ADDENDUM NO. 3

**Difficult Run Raw Sewage Pump Station Rehabilitation
CONTRACT NO. CN14402005
PROJECT NO. WW-000001-009**

This addendum is supplementary to the contract documents for the Difficult Run Raw Sewage Pump Station Rehabilitation Project.

ADDENDUM NO. 3	DATE 06/25/15	FAIRFAX COUNTY, VIRGINIA DPWES	H & S JOB NUMBER 32236-001	REFER TO CONTRACT DRAWING NUMBER M101
ATTACHMENT NO. 4	BY MKS	DIFFICULT RUN RAW SEWAGE PUMP STATION REHABILITATION	CONTRACT NUMBER CN14402005	SHEET 1 OF 1

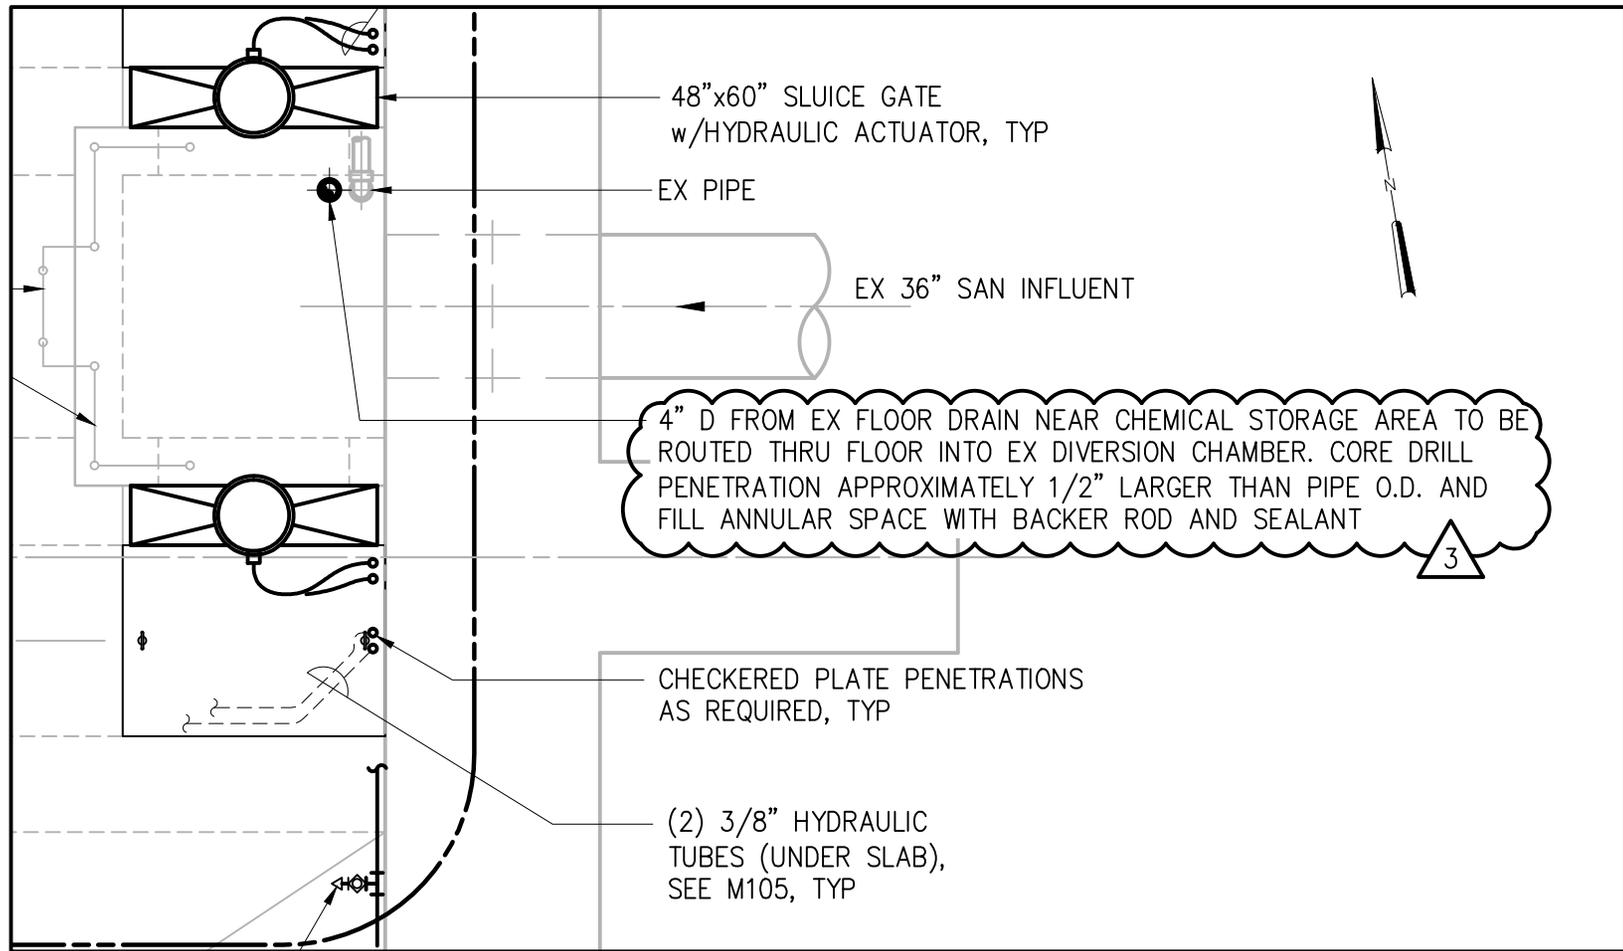
3.30	Drawings C5	DELETE "Pavement Junction" callout with reference to detail 0251301 adjacent to existing concrete bridge deck on Drawing C5.
3.31	Drawing M101	REPLACE with call out on Drawing M101 as shown in Attachment 4 . "4" D from existing floor drain near chemical storage area to be routed thru floor into existing diversion chamber. Core drill penetration approximately 1/2" larger than pipe O.D. and fill annular space with backer rod and sealant."

ADDENDUM NO. 3	DATE 06/25/15	FAIRFAX COUNTY, VIRGINIA DPWES	H & S JOB NUMBER 32236-001	REFER TO CONTRACT DRAWING NUMBER M106
ATTACHMENT NO. 5a	BY MKS	DIFFICULT RUN RAW SEWAGE PUMP STATION REHABILITATION	CONTRACT NUMBER CN14402005	SHEET 1 OF 2

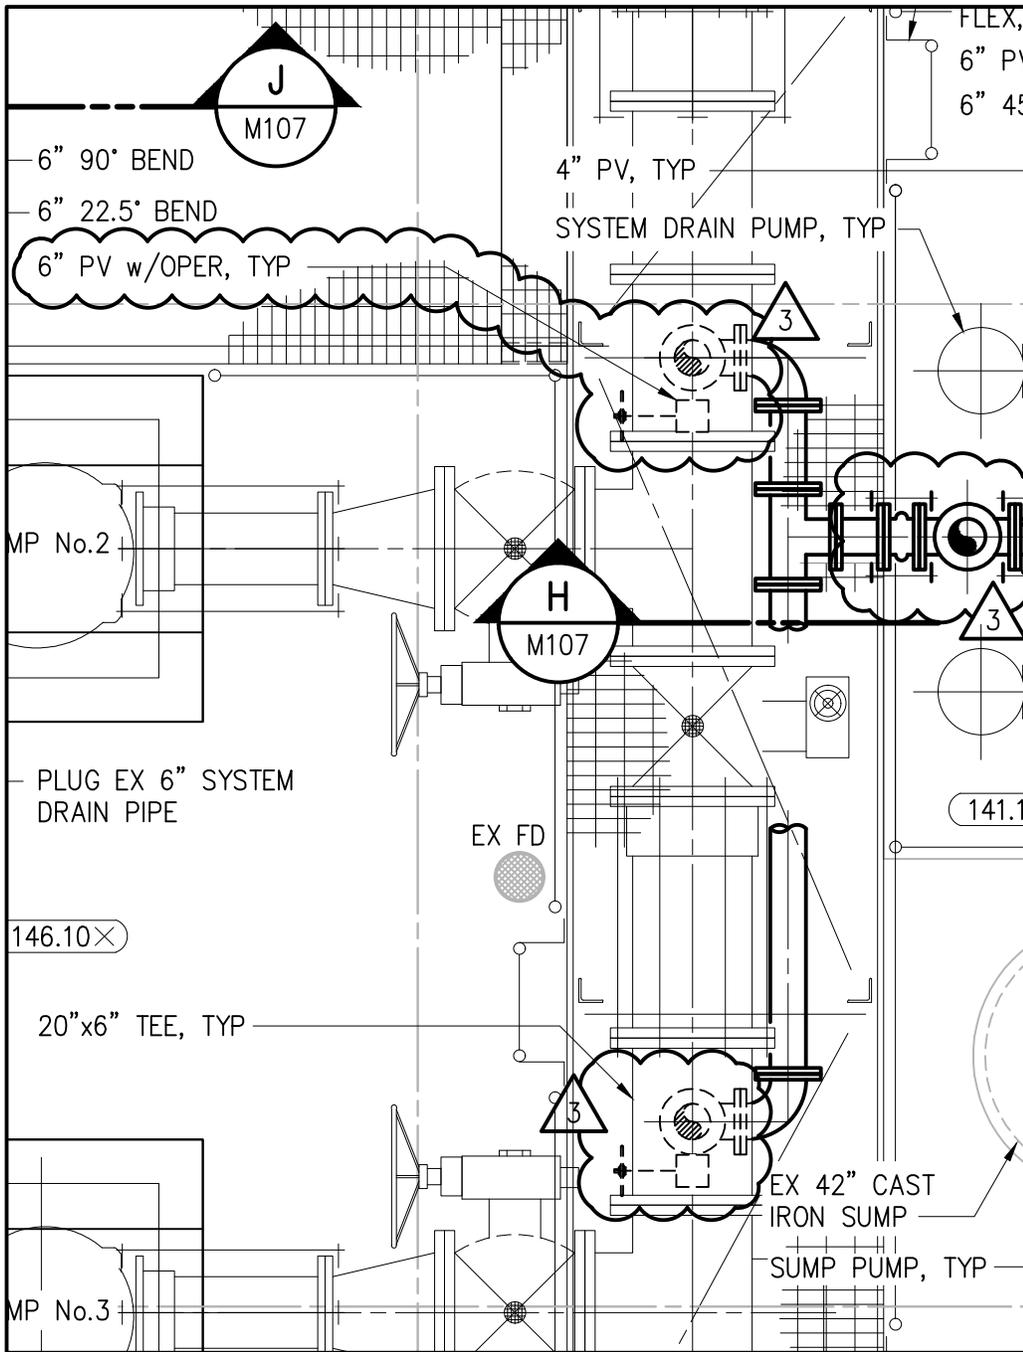
3.34	Drawings M106 and M107	ADD a total of two 6-inch plug valves and operators in the vertical directly downstream of the two system drain pump suction connections to the 20-inch Pump Suction Header (one 6-inch plug valve for each connection) to Drawings M106 and M107 as shown in Attachments 5a and 5b .

ADDENDUM NO. 3	DATE 06/25/15	FAIRFAX COUNTY, VIRGINIA DPWES	H & S JOB NUMBER 32236-001	REFER TO CONTRACT DRAWING NUMBER E112
ATTACHMENT NO. 6	BY MKS		CONTRACT NUMBER CN14402005	SHEET 1 OF 1

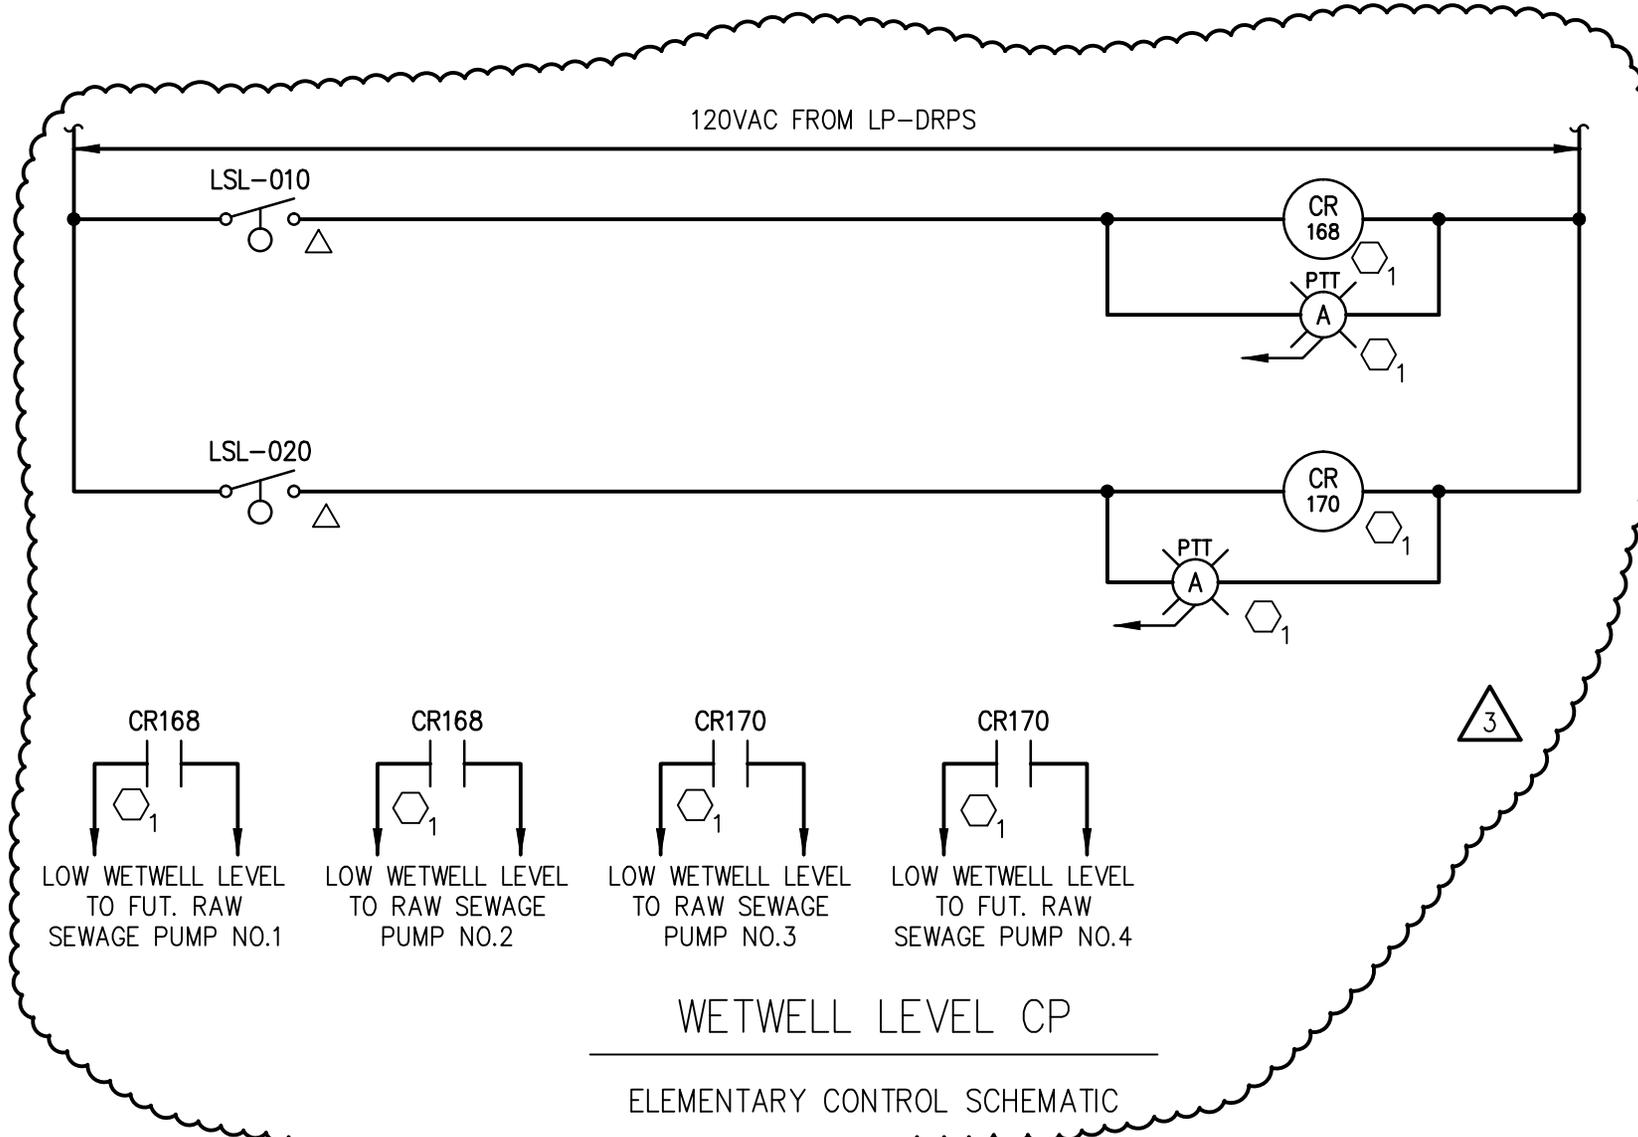
3.43	Drawing E1	ADD Note 13, as follows: "13. Refer to Specification 16000 for scope of Electrical demolition work within the Pump Station"
3.44	Drawing E112	ADD the elementary control schematic shown in Attachment 6 to

ADDENDUM NO. 3	DATE 06/25/15	FAIRFAX COUNTY, VIRGINIA DPWES	H & S JOB NUMBER 32236-001	REFER TO CONTRACT DRAWING NUMBER D1
ATTACHMENT NO. 7	BY MKS	DIFFICULT RUN RAW SEWAGE PUMP STATION REHABILITATION	CONTRACT NUMBER CN14402005	SHEET 1 OF 1

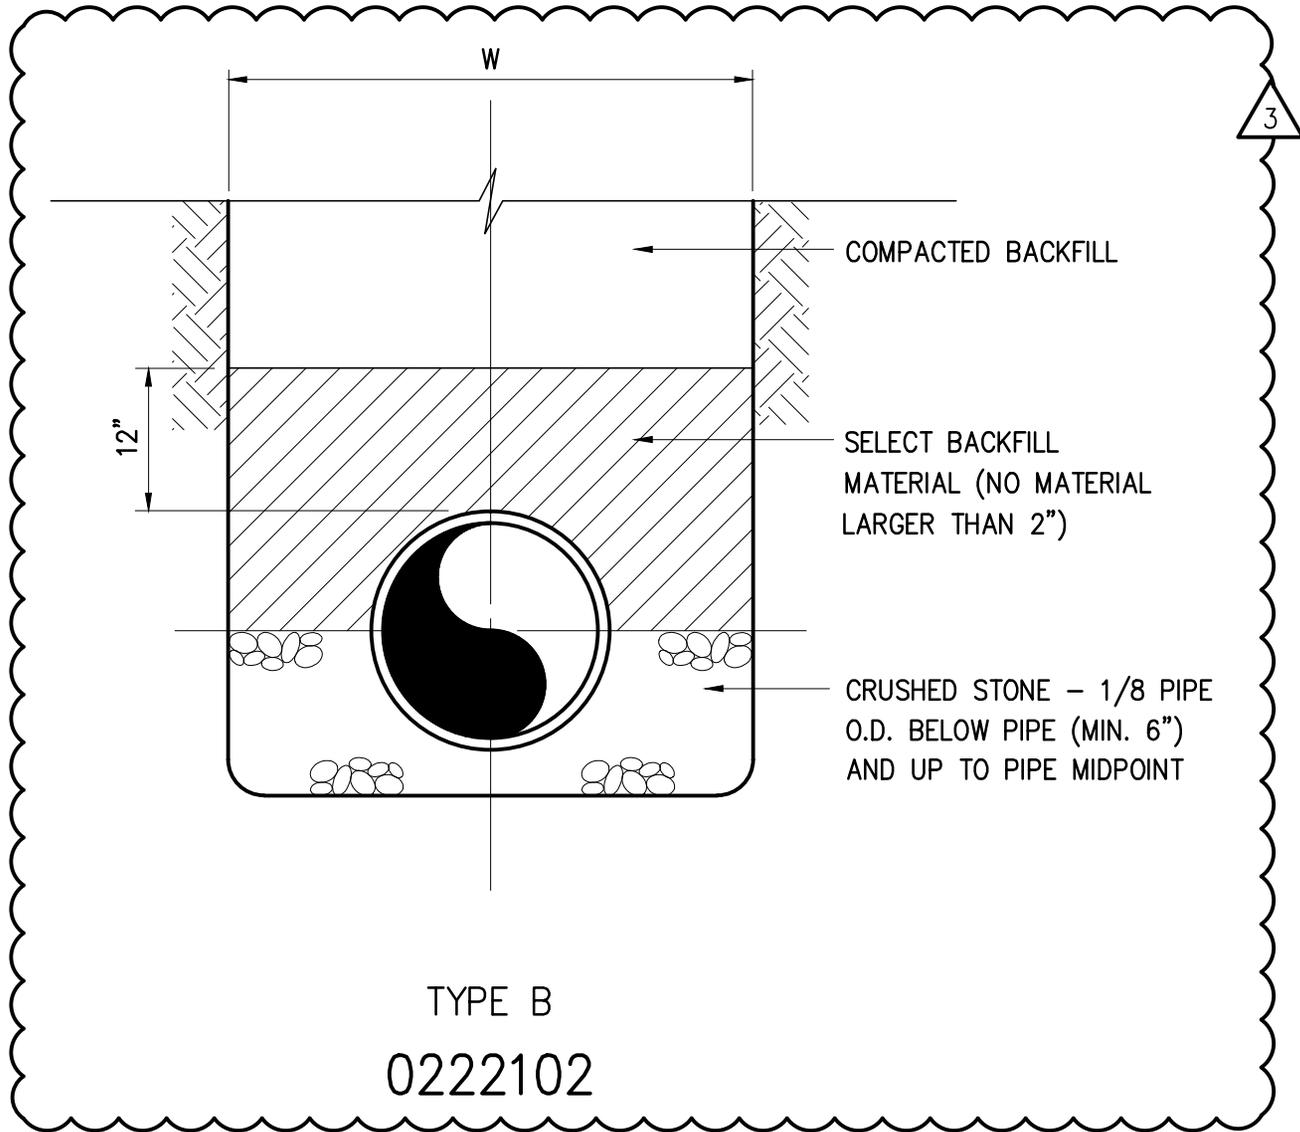
DOCUMENT	DESCRIPTION
		Drawing E112.
3.45	Drawing D1	ADD Detail 0222102 to Drawing D1 as shown in Attachment 7 .
3.46	Drawing D3	REMOVE Note 2 from Detail 0257500 on Drawing D3.
3.47	Drawing D11	ADD Detail entitled "Duct Bank Termination at Concrete Wall" to Sheet D11 as shown in Attachment 8
3.48	Drawing P100	REPLACE Drawing P100 with Attachment 9
